TOPIC STATEMENT OF COMMON GROUND – LIVING CONDITIONS RfR5

APPEAL REFERENCE APP/X3540/W/19/3242636

APPELLANT Capital Community Developments Ltd

Land North Of Gardenia Close And Garden Square Rendlesham Suffolk.

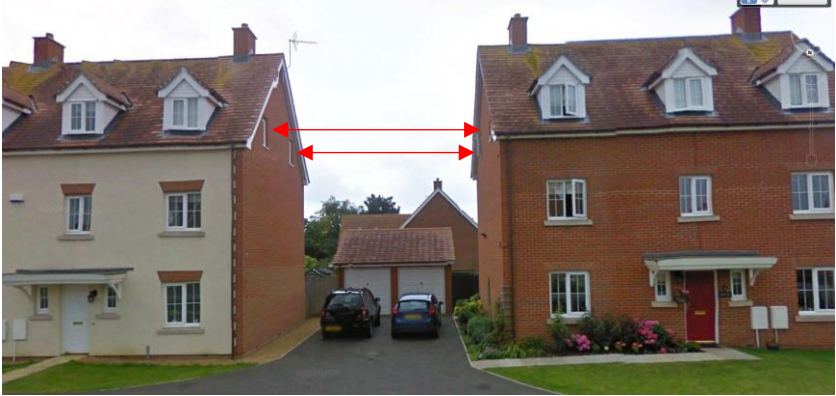
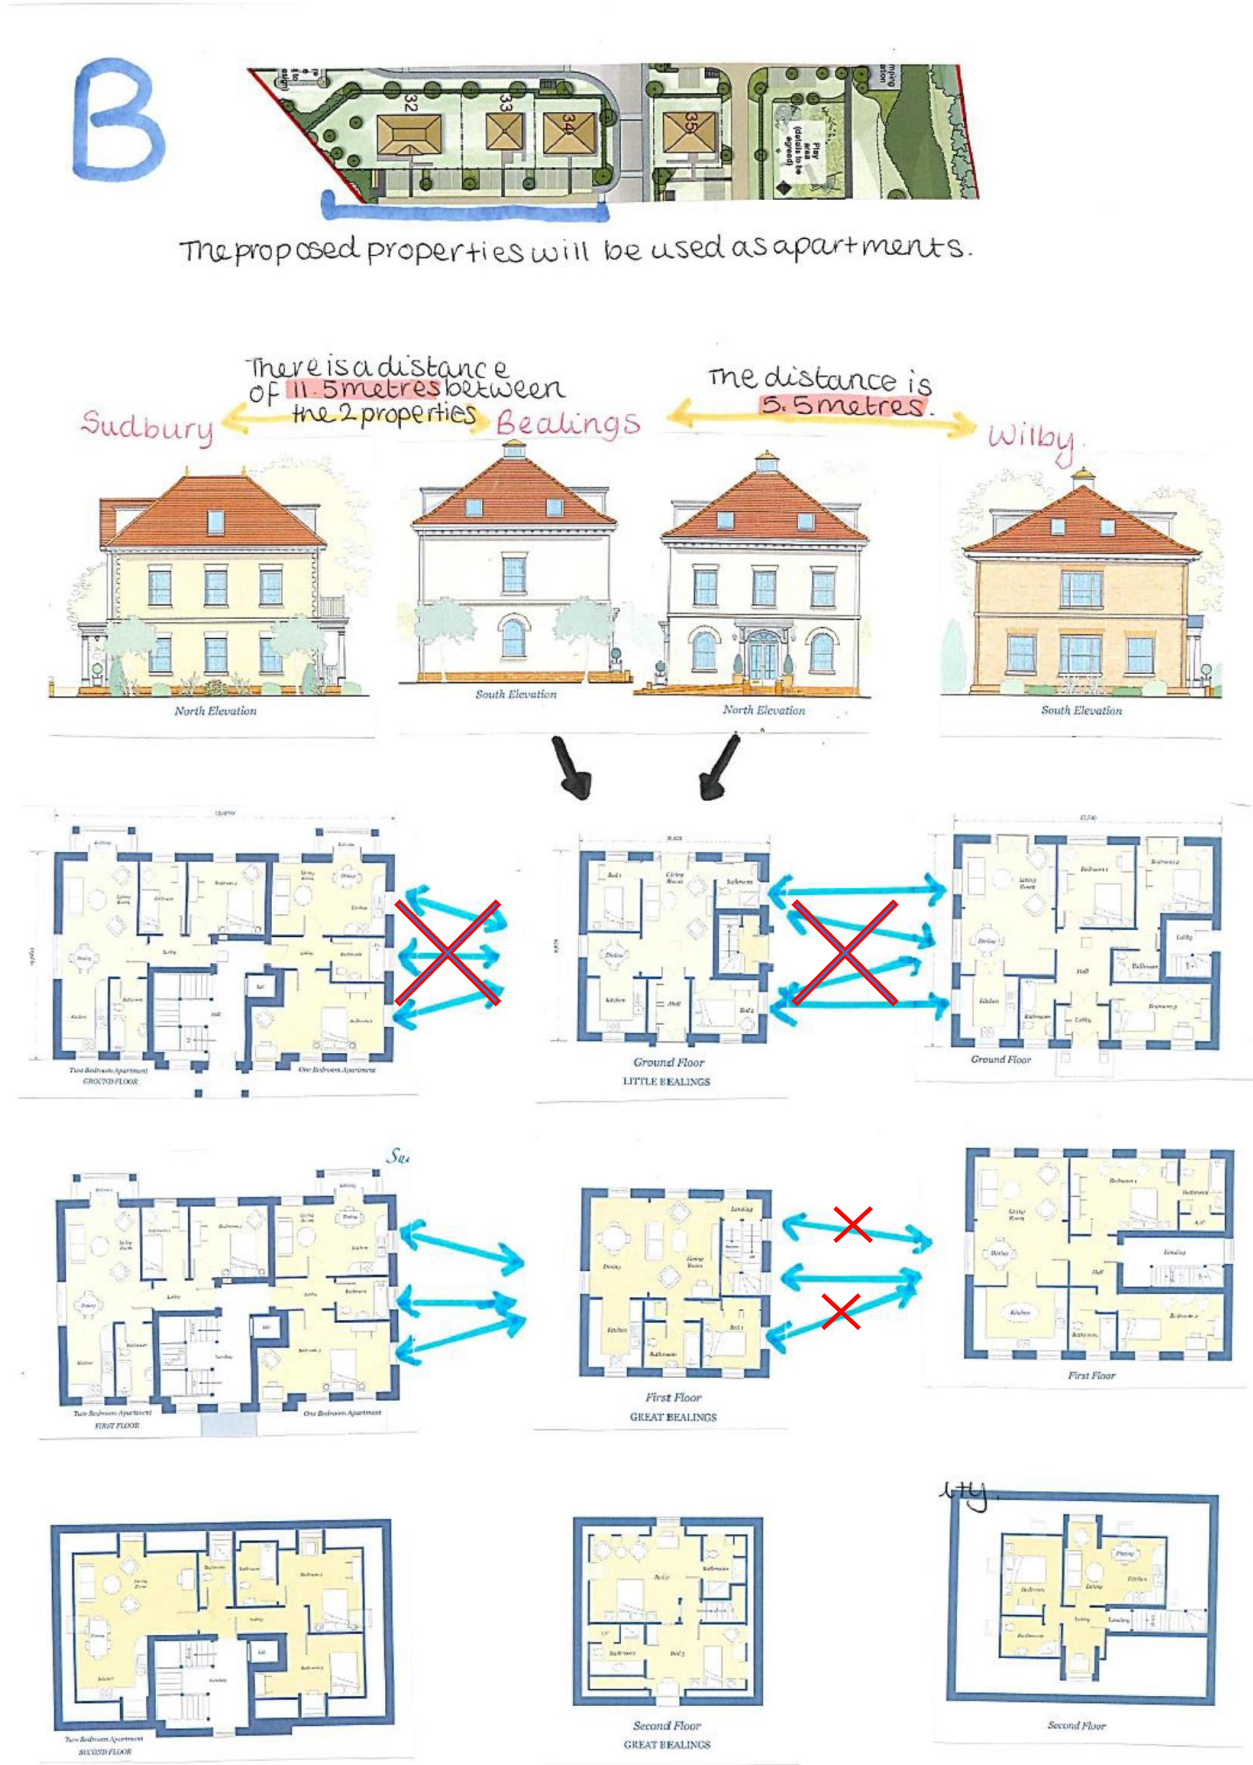
Both are bedroom windows.

Elevations of concern are the North elevation of the Framlingham style property and on the Glenham the South Elevation.

The inset part of the site location plan to the left shows the properties are offset from each other. Had the LPA have overlaid the inset floor plans with the site layout plan then the appropriate offset angle would have been achieved. The LPA have shown the properties aligned with each other, exaggerating the level of intervisibility.

The inset elevation drawings do not have the benefit of the ground level 2m high fences. There would be limited or no intervisibility between properties at ground floor because of the fences.

The inset plan below shows how, in reality, the intervisibility through narrow slot windows is a lot less than the LPA claim. If the Inspector is inclined to agree with the LPA than even this lessened intervisibility is an amenity impact worthy of further consideration, then it seems appropriate to consider whether obscure glazing the window would have sufficed to overcome the objection in the first place, thus negating this appeal:

The LPA have used the ‘Plot 15 variant’ (left) instead of the ‘standard’ Bealings (right):

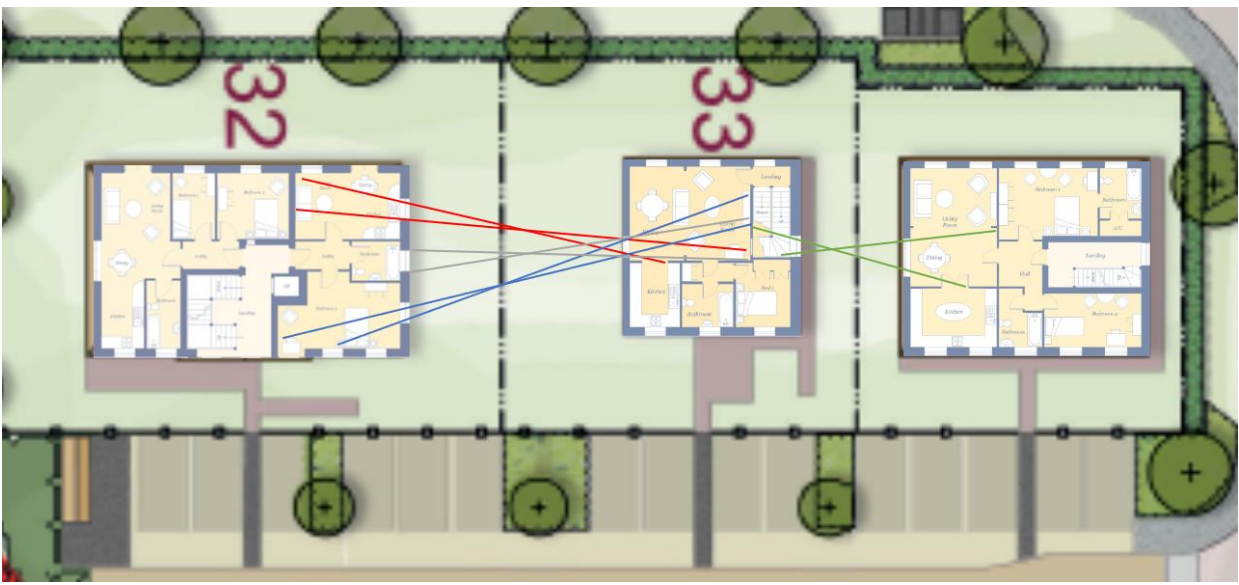
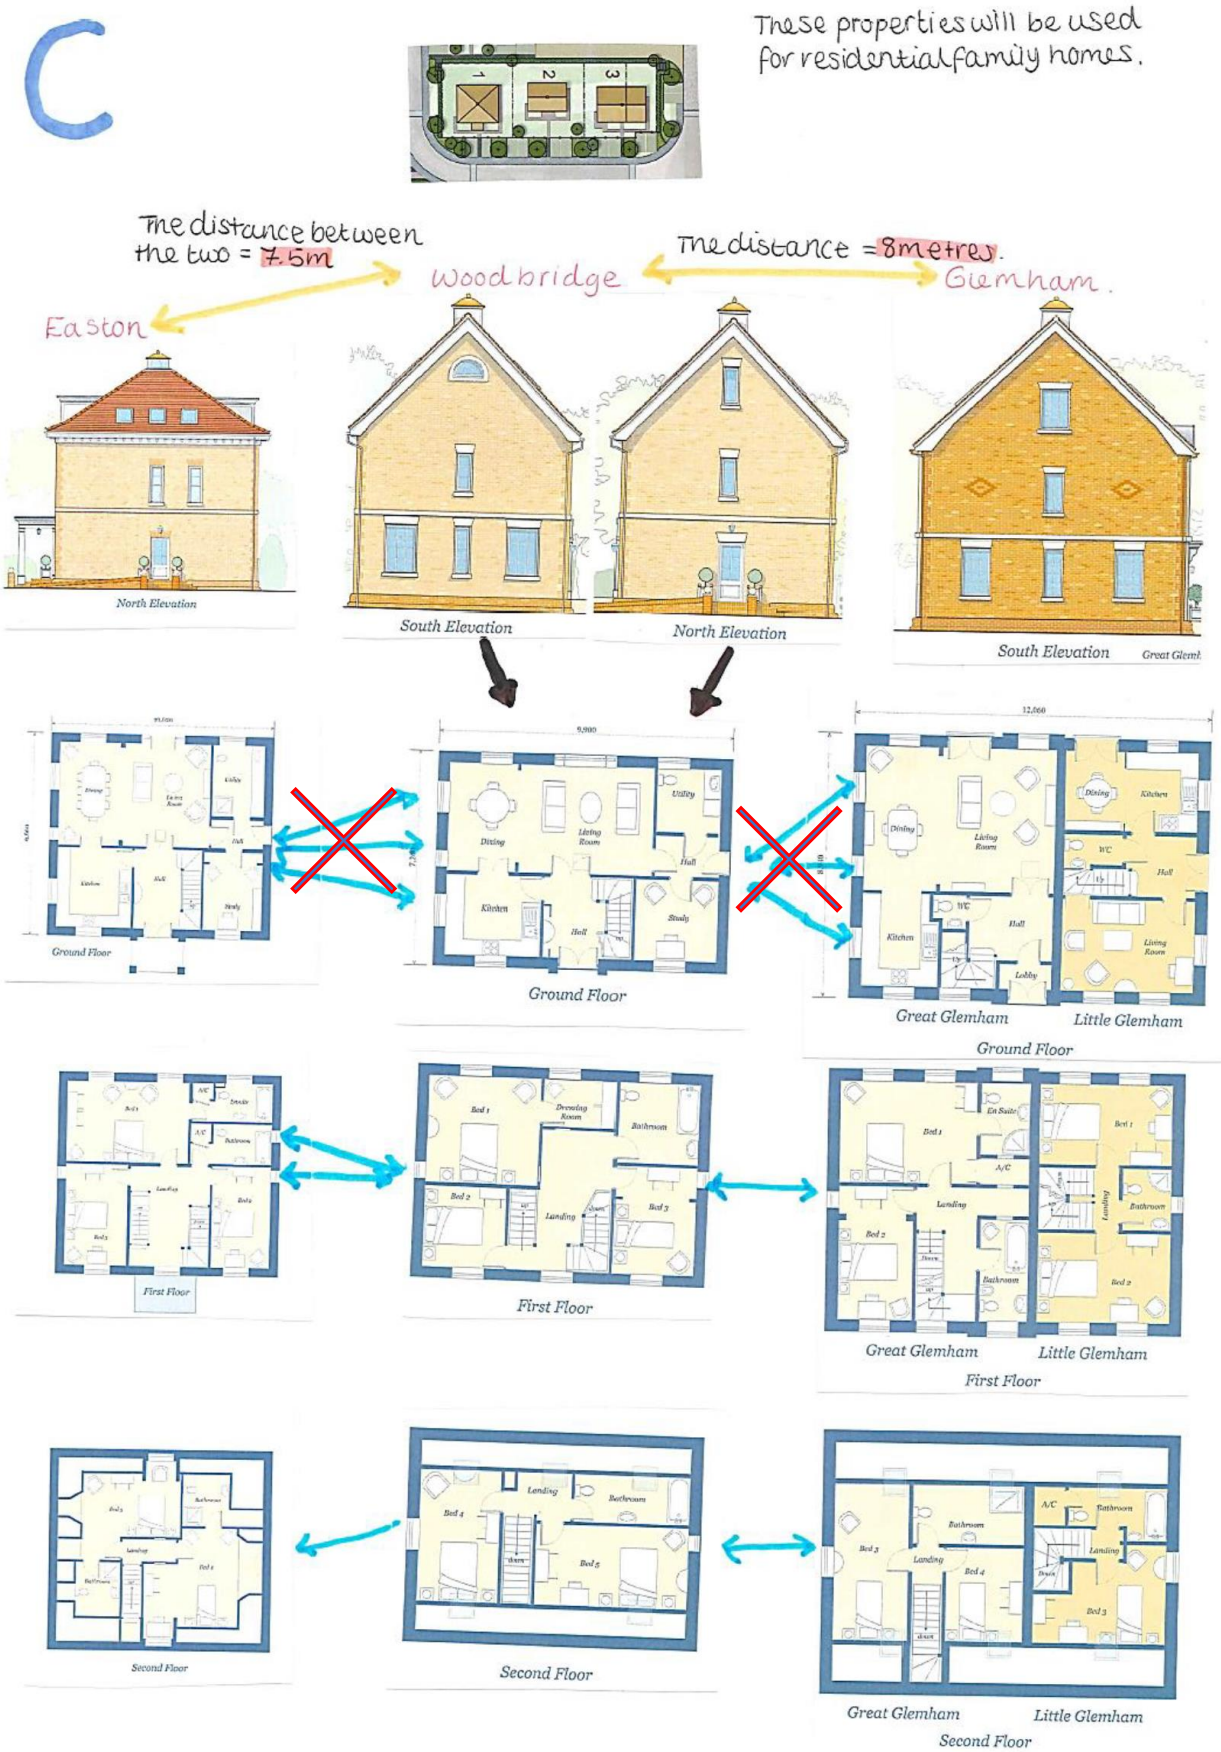
Of the 6x matters indicated at first floor on the image to the left we make the following comments:

- The 1x instance of potential overlooking between the first floor south elevation window of the Bealings building and the bathroom window of the north elevation of the Sudbury building (grey lines on inset plan below) are not possible because it should be assumed the bathroom window would be obscured glazed.

- The 1x instance of potential overlooking from the first floor south elevation windows of the Bealings building to the living room of the northern first floor elevation of the Sudbury (red lines below) would be through a relatively narrow window on the Bealings and because this is not one of the principle windows in this property it could be obscure glazed or frosted if the decision maker found it necessary to do so.

- The same is the case for the instance between the Bealings first floor southern elevation window and the Sudbury first floor northern elevation bedroom window (blue lines below); it too could be solved by obscure glazing the Bealings window.

- The 2x instances of potential overlooking between the first-floor southern elevation window in the Wilby building to the northern elevation windows of the Bealings **are only in fact 1x instance because the LPA have used the wrong floor plan for the Bealings at first floor in their evidence.** The remaining instance (green lines) is from the landing area of the Bealings and therefore is hardly an amenity issue. There are two ways to approach this if need be; to obscure glaze the Bealings stairwell window as it only serves a transitory area or narrow the window of the Wilby to reduce the angle of incidence of the view by way of a minor amendment IF the LPA or Inspector think it necessary.

- The 1x instance of potential overlooking between the Wilby first floor southern elevation window and the first floor bedroom window of the Bealings on the northern elevation is non-existent **because the LPA have used the wrong floor plan for the Bealings at first floor in their evidence.**

None of the 6x instances of potential first floor overlooking between the properties in ‘Area B’ on the LPAs drawing cannot be dealt with by way of simple planning controls and should have been the subject of requests for information from the LPA during the course of the planning application. The appellant is content that the solutions listed above be condition if the Inspector considers it necessary to do so.

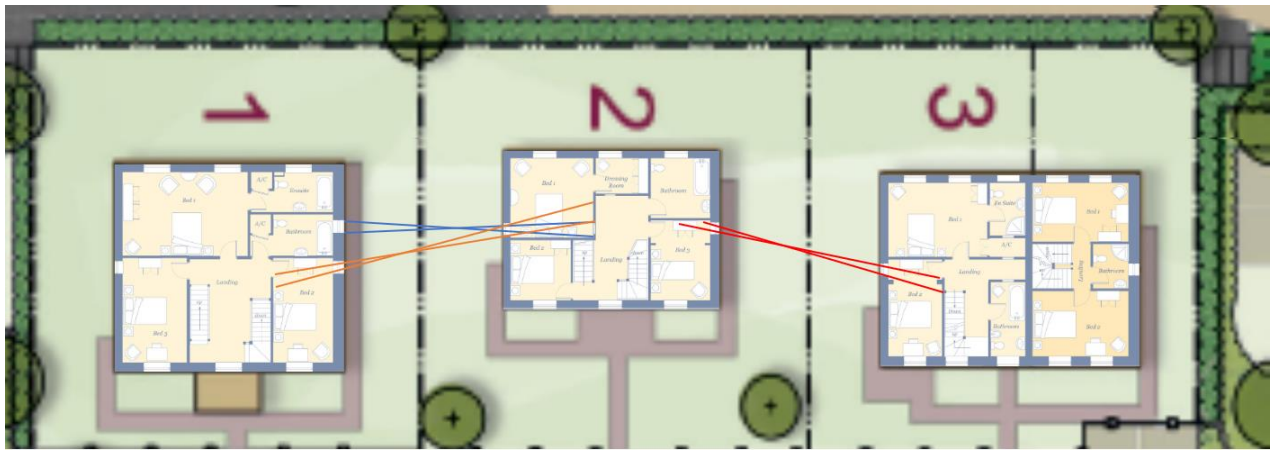
Of the 3x instances of potential overlooking indicated by the LPA at the first floor level we make the following comments:

- The 1x instance of potential overlooking between the bathroom window at first floor in the Easton and the Woodbridge (blue lines) should have been assumed by the LPA to be resolved by the inserted of obscure glazing by condition.

- The 1x instance of potential overlooking between the first floor northern elevation bedroom of the Easton and the first floor southern elevation bedroom of the Woodbridge (orange lines) is at an obscure angle not accurately represented by the LPA in their evidence. If the Inspector considers it necessary, either of the windows could be obscure glazed.

- The 1x instance of potential overlooking between the first floor northern elevation bedroom window of the Woodbridge and the first floor southern elevation bedroom window of the Glenham (red lines) is at a very obscure angle not accurately represented by the LPA in their evidence. If the Inspector considers it necessary, either of the windows could be obscure glazed.

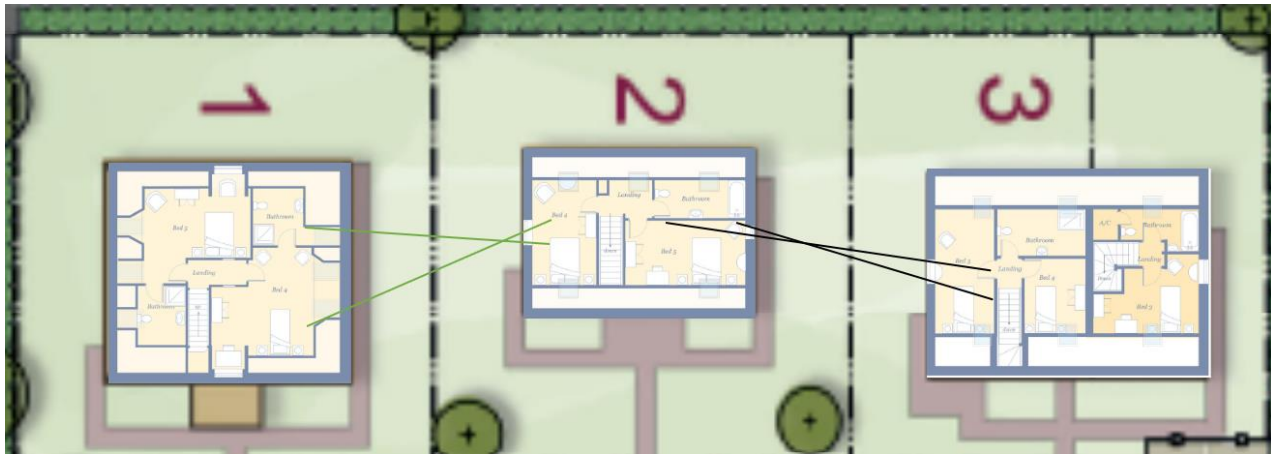
Of the 2x instances of potential overlooking indicated by the LPA at the second floor level we make the following comments:

- The potential view from plot 3 (Glenham) at second floor level is via a half-moon window with a 1.7m cill height and a such is unlikely to afford significant views that would cause an unacceptable loss of residential amenity.
- The 1x instance of potential overlooking between the second floor northern elevation bedroom window of the Woodbridge and the second floor southern elevation bedroom window of the Glenham is highly unlikely because of the obscure angle which means there is a very small area of the bedroom space in the Woodbridge in which someone would have to be standing to cause a problem.

None of the 11 instances of potential overlooking in the LPAs 'Area C' of its evidence bear scrutiny.

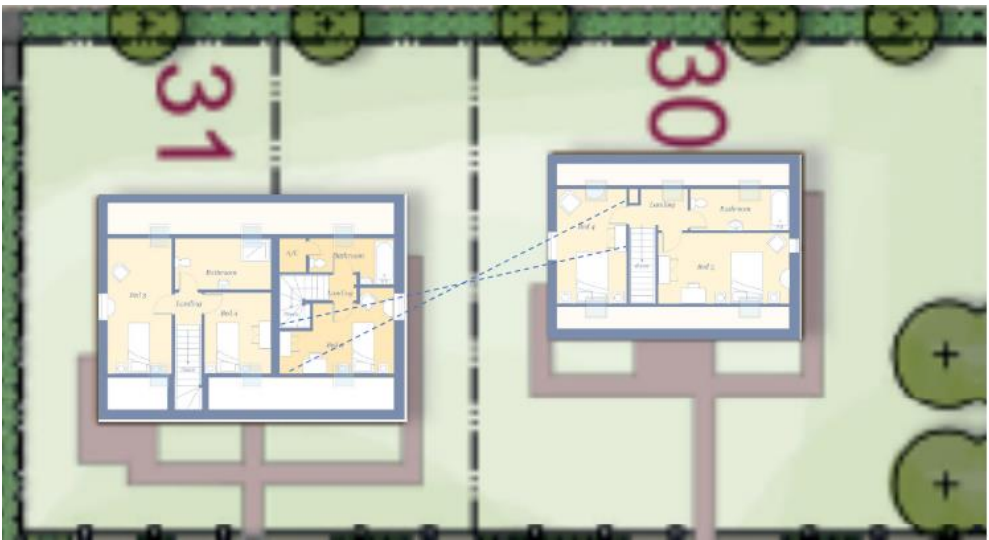
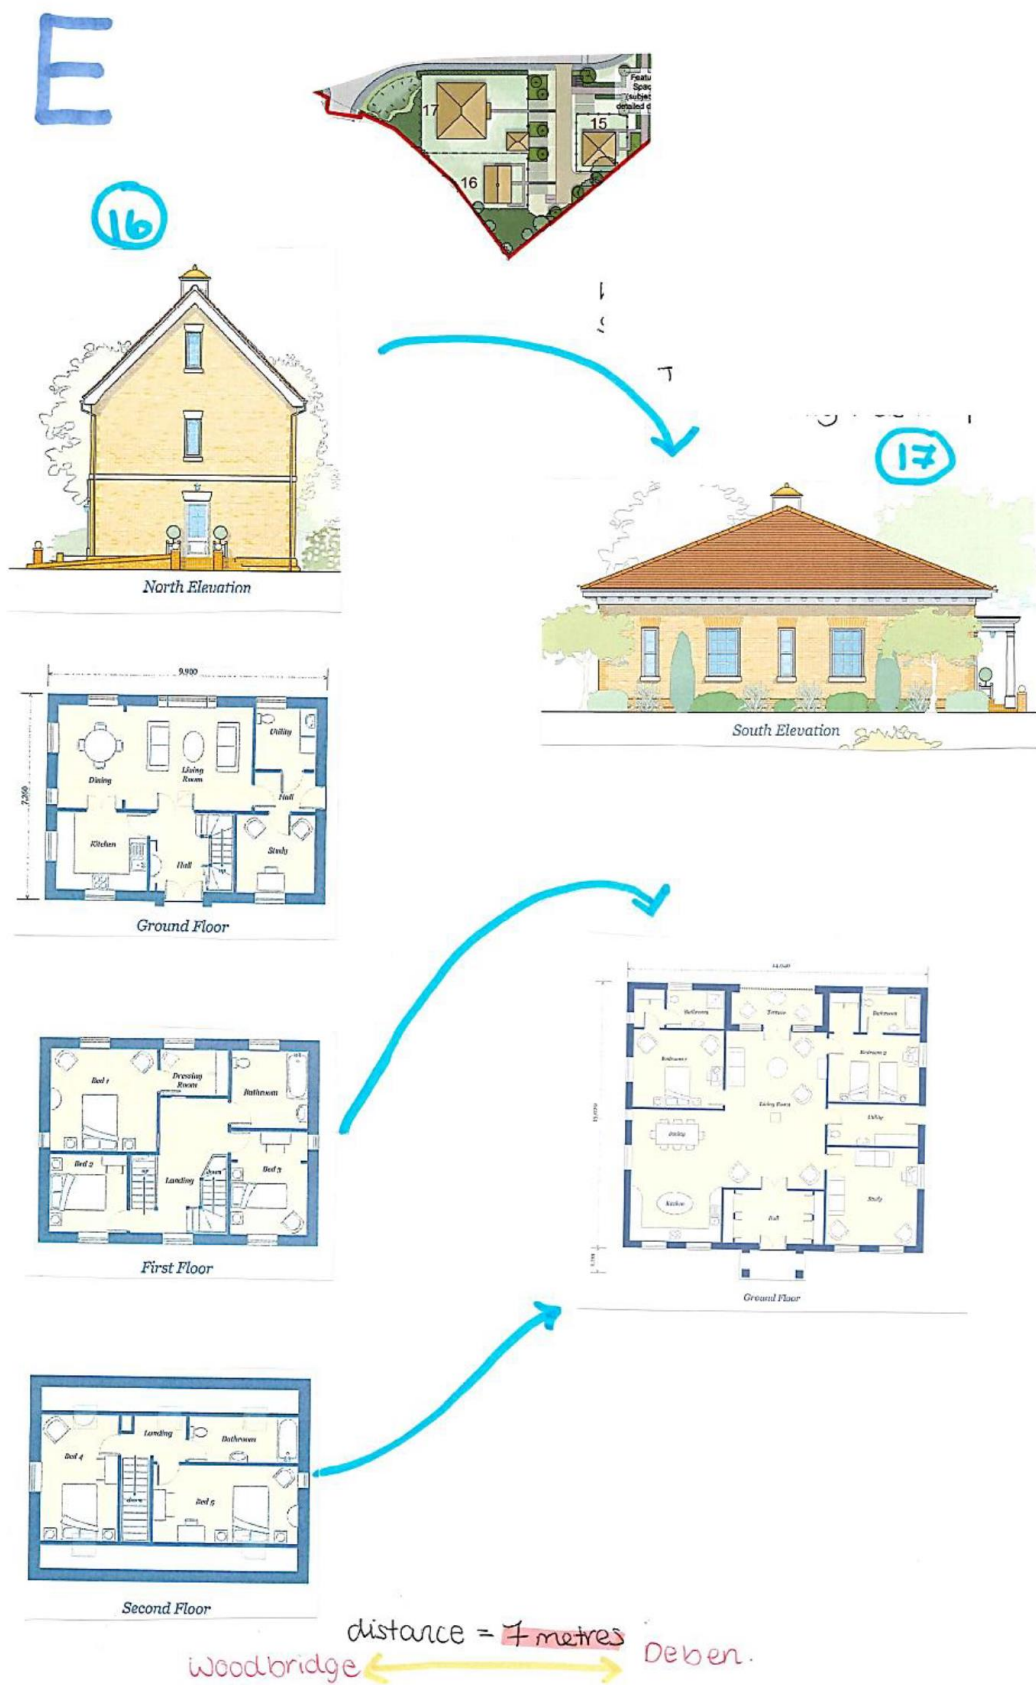
Of the 1x instance of potential overlooking indicated by the LPA at the first floor level we make the following comments:

Of the 1x instance of potential overlooking indicated by the LPA at the second floor level we make the following comments:

- The instance which the LPA allude to is to a bathroom window which their own document appears to acknowledge would be obscure glazed.

- The potential view from plot 31 (Glemham) at second floor level is via a half-moon window with a 1.7m cill height and a such is unlikely to afford significant views that would cause an unacceptable loss of residential amenity.

Neither of the two issues which the LPA use in evidence bear scrutiny.
